# UNITED STATES PATENT AND TRADEMARK OFFICE

APPLICATION NO.	FILING DATE	FIRST NAMED INVENTOR	ATTORNEY DOCKET NO.	CONFIRMATION NO.
10/598,728	09/08/2006	Harri Juntunen	AWEK 3513	9474
7812	7590	10/10/2008		
SMITH-HILL AND BEDELL, P.C. 16100 NW CORNELL ROAD, SUITE 220 BEAVERTON, OR 97006			EXAMINER O BRIEN, JEFFREY D	
			ART UNIT 3677	PAPER NUMBER
			MAIL DATE 10/10/2008	DELIVERY MODE PAPER

<b>Office Action Summary</b>	<b>Application No.</b> 10/598,728	<b>Applicant(s)</b> JUNTUNEN, HARRI	
	<b>Examiner</b> Jeffrey O'Brien	<b>Art Unit</b> 3677

## **DETAILED ACTION**

annotated  
FIG. 1

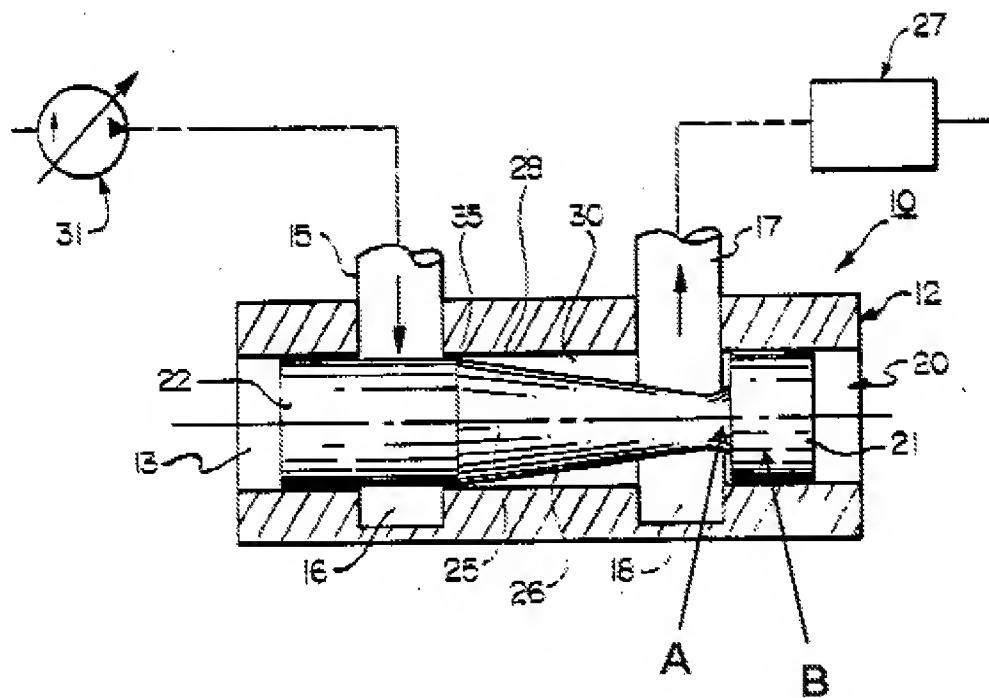
7. '919 teaches a valve having a beveled end (Fig. 1: 26) of a control part and at the beveled end of the control part, a support part (annotated Fig. 1: A) and a collar (B) that is a resilient material (wherein '919 is silent as to the material, but wherein bearings or collars are typically metal or plastic, both of which have some amount of resiliency) and can be placed around the support part (A) for providing a supporting surface that can be place against the housing body. It would have been obvious to one of ordinary skill in the art at the time of the invention to apply the support part and collar of the valve of
